Final Second Five-Year Review Report Palermo Wellfield Superfund Site Tumwater, Washington

EPA Region 10

September 2008

Figure 4-4
Palermo Wellfield Superfund Site
Second Five-Year Review
Piezometric Contour Map with
TCE Concentrations in Groundwater
May 2008

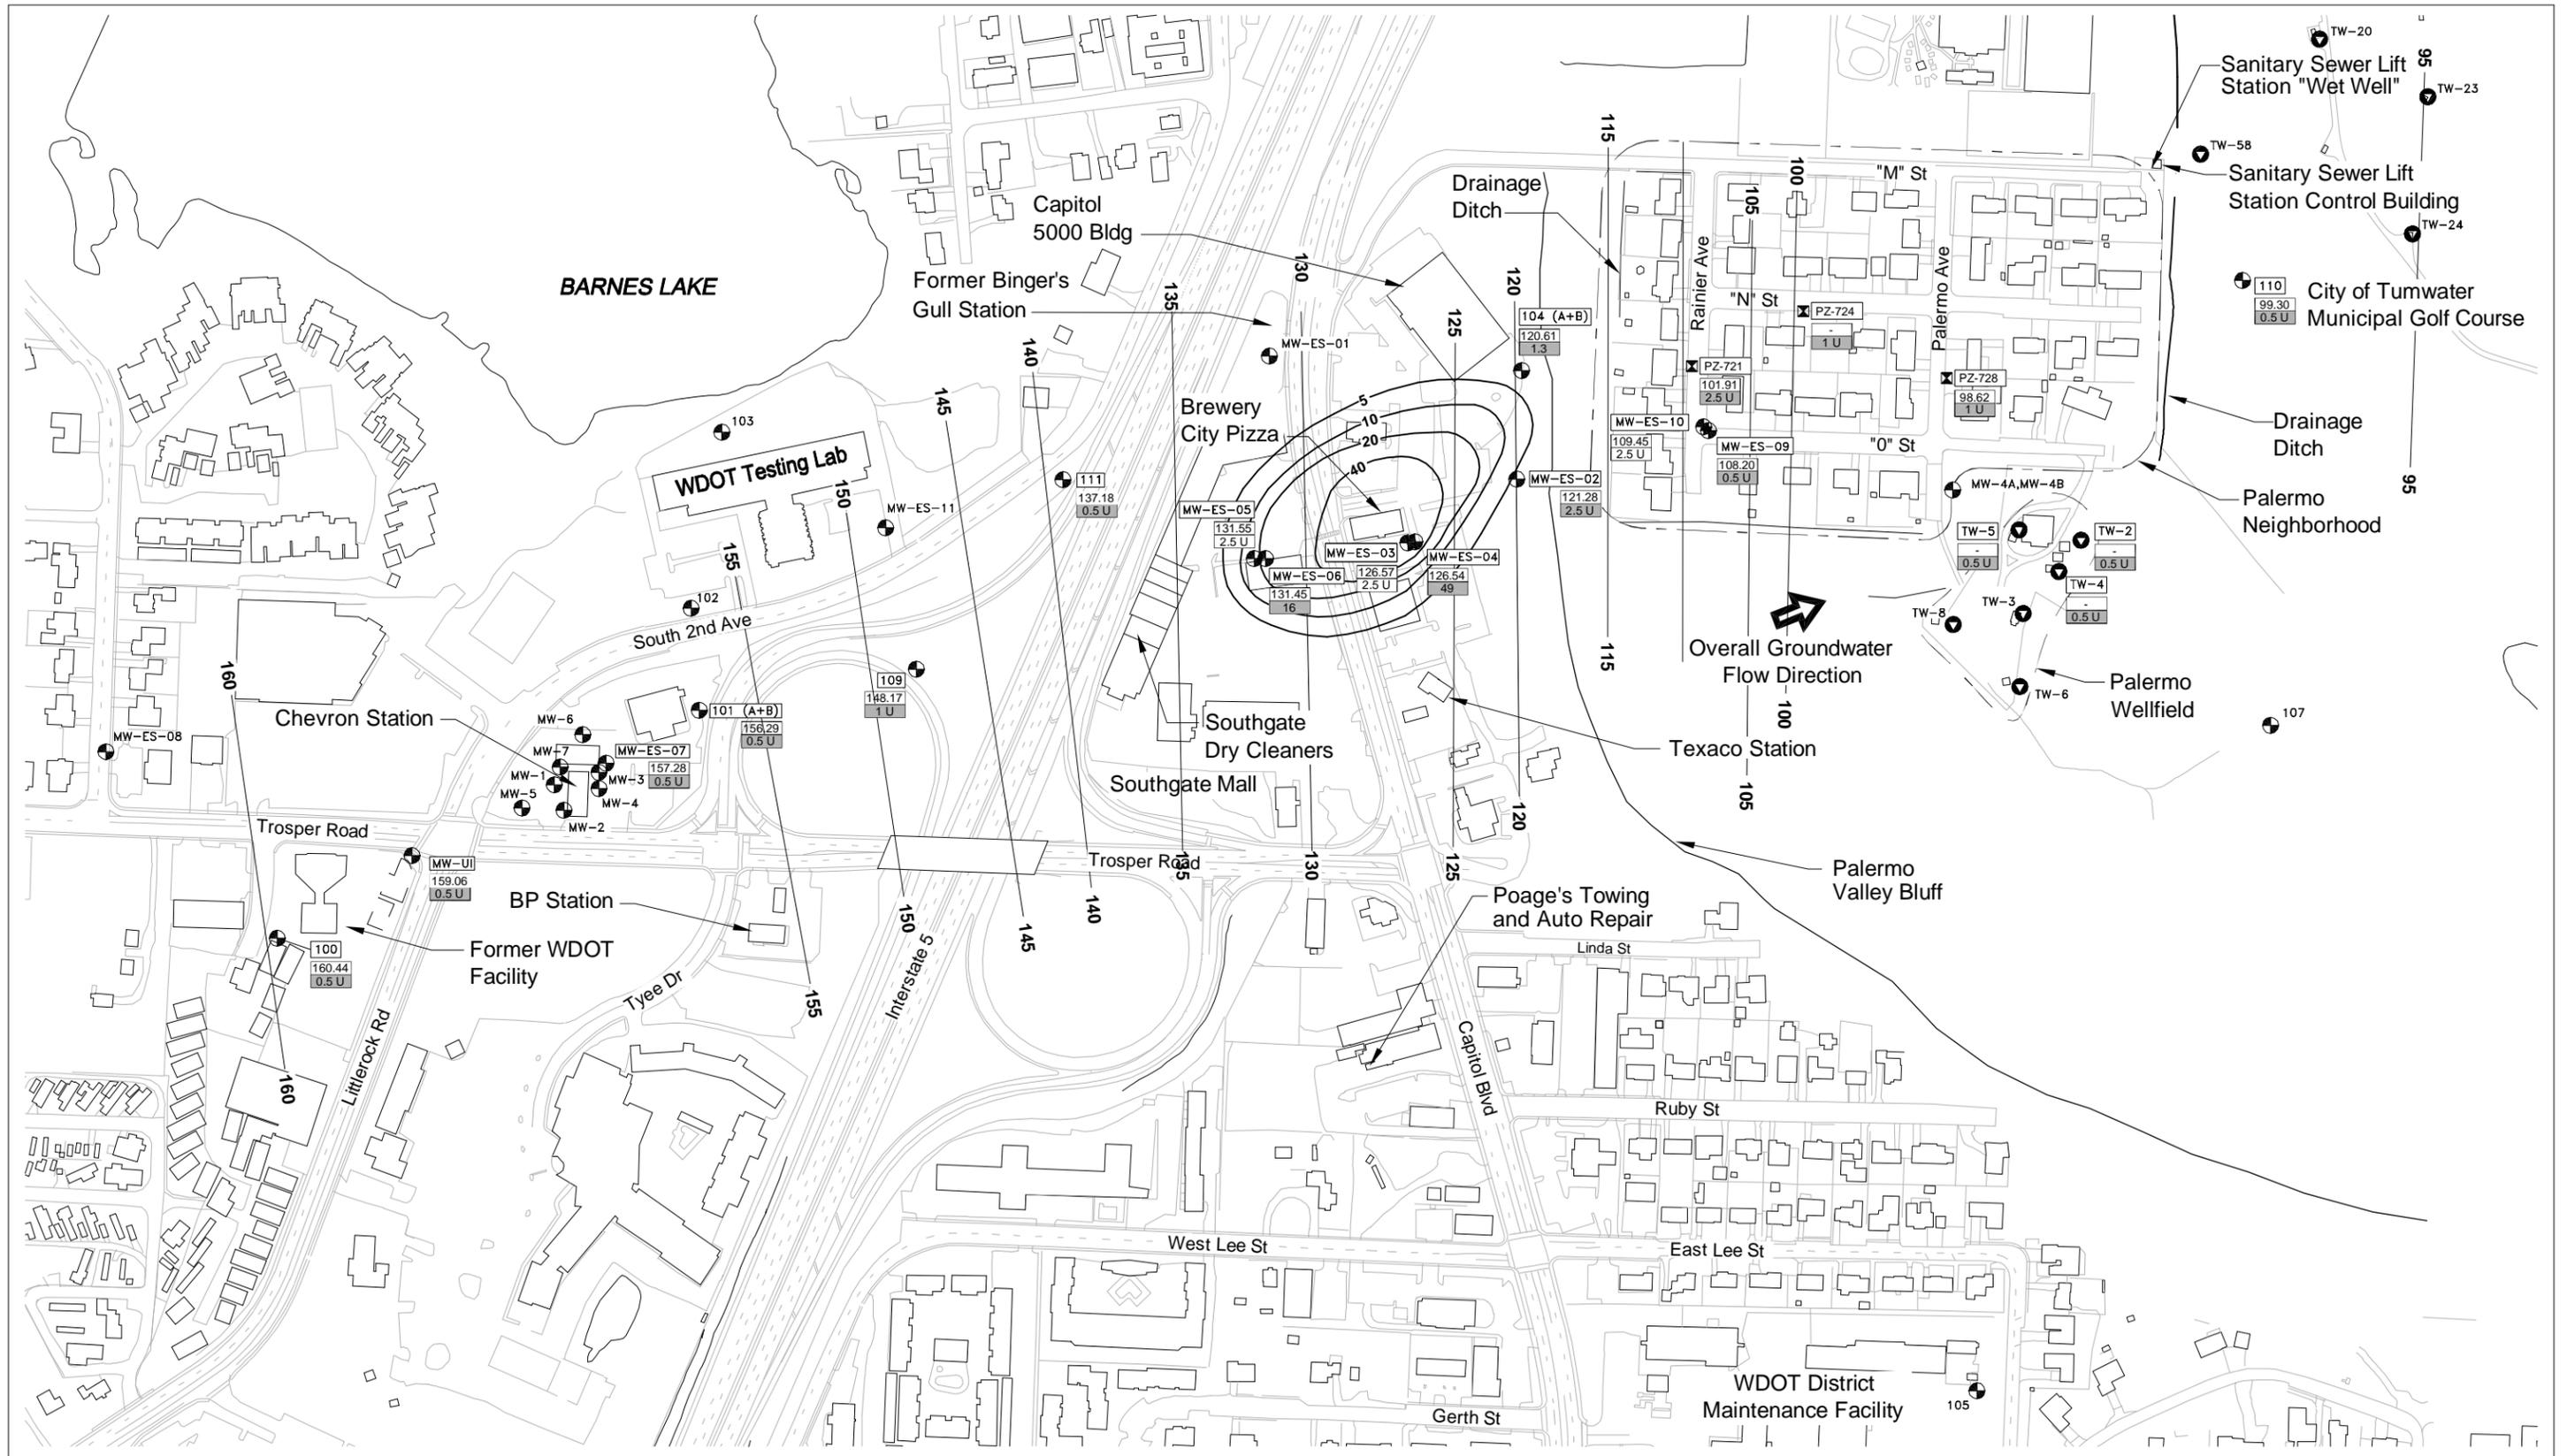
7. **Section 4.3.4, Component 5 – Long-Term Groundwater Monitoring** – Figure 4-4 and 4-5 do not appear to be correctly constructed (shallow and deep wells were used together to construct groundwater concentration and flow maps). Correctly constructed figures are necessary for understanding groundwater flow and potential exposures and to evaluate possible health risks.

11. **Section 7.1.4, Long-Term Groundwater Monitoring, First Sentence** – The report notes that the Palermo Wellfield is capturing the groundwater contaminant plumes. However, this conclusion is not supported by Figure 4-4 and the 2004 through 2007 *Groundwater Long-Term Monitoring Reports*, which suggest that the Palermo Wellfield is not capturing all the contaminated groundwater. This situation could pose a health risk if the contaminated groundwater is pulled toward other water supply wells, such as the Pabst Brewery wells, located northeast of the site, or discharging into the nearby Deschutes River.

**Figure 4-5
Palermo Wellfield Superfund Site
Second Five-Year Review
Piezometric Contour Map with
PCE Concentrations in Groundwater
May 2008**

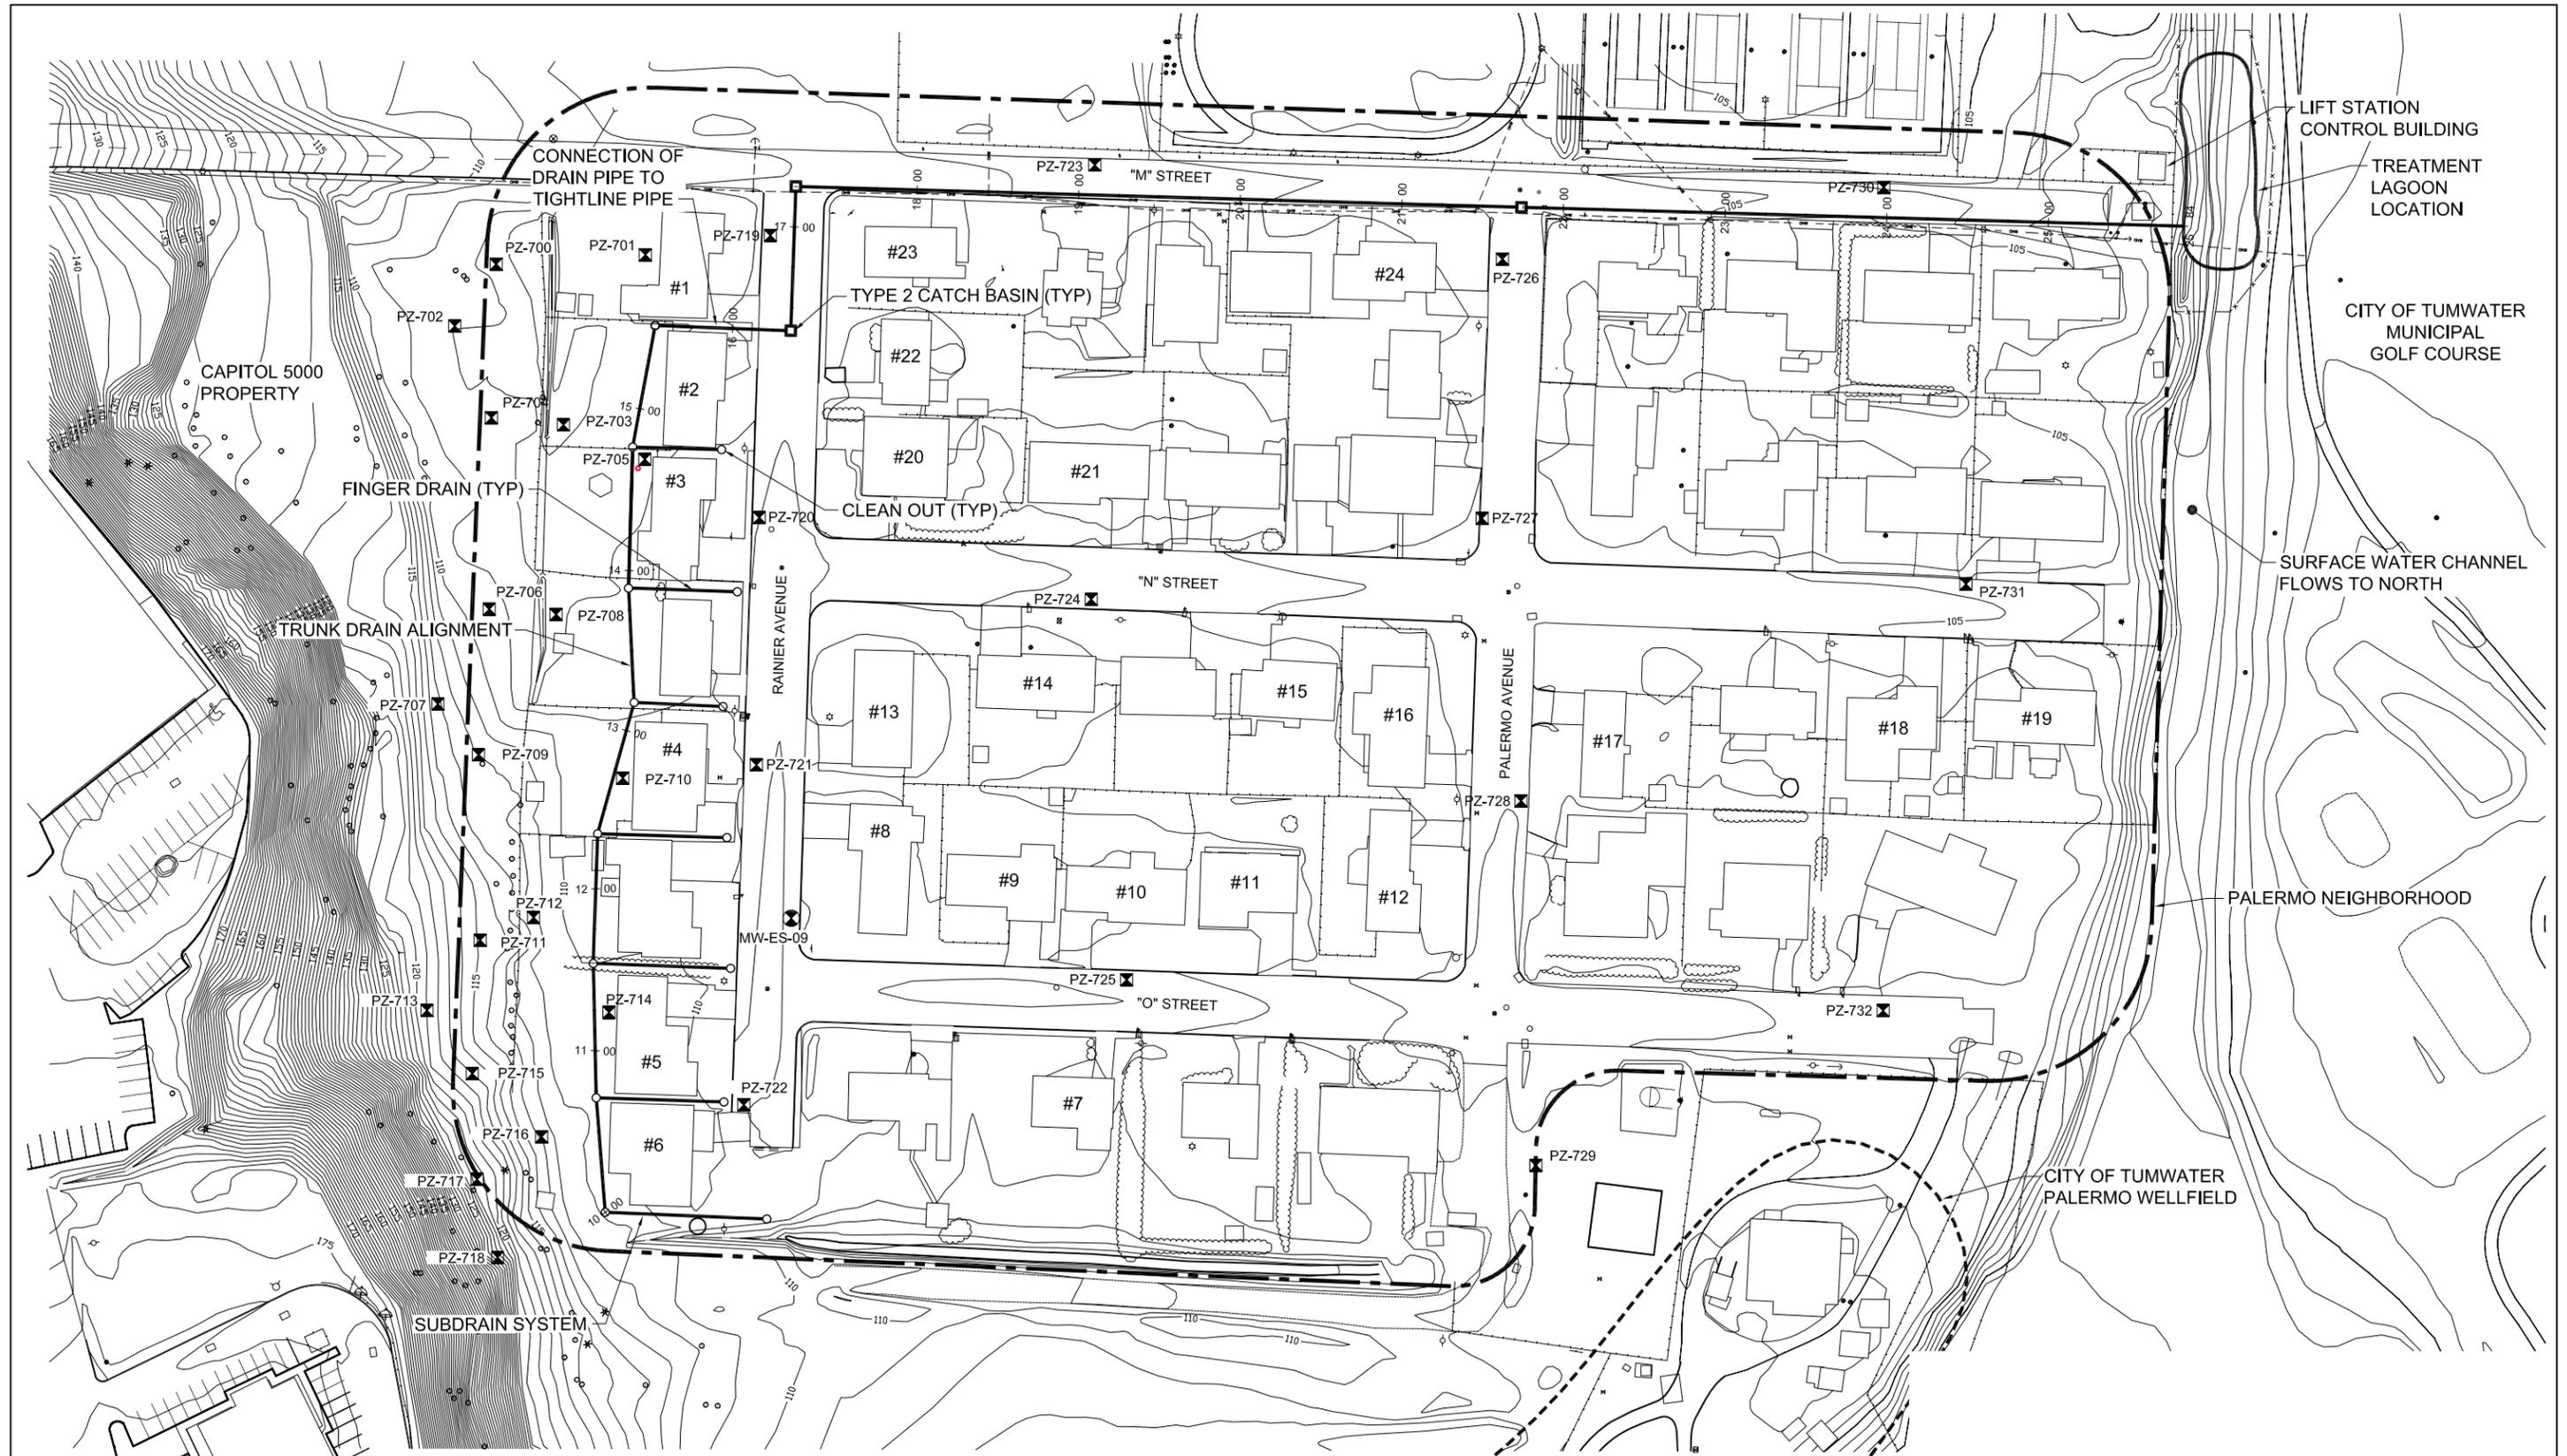
- b. **A monitoring well(s) should be placed downgradient of the Southgate Dry Cleaners to evaluate and monitor the long-term effectiveness of the SVE source removal.**
- c. **Figure 4-5 should be modified to indicate that PCE has been found at CO6.** Figure 4-5 represents PCE concentrations in groundwater and shows that PCE “cleans up” before it reaches the Palermo bluffs or neighborhood. This is misleading. Subdrain sampling results (CO6/Station 357) indicate PCE is
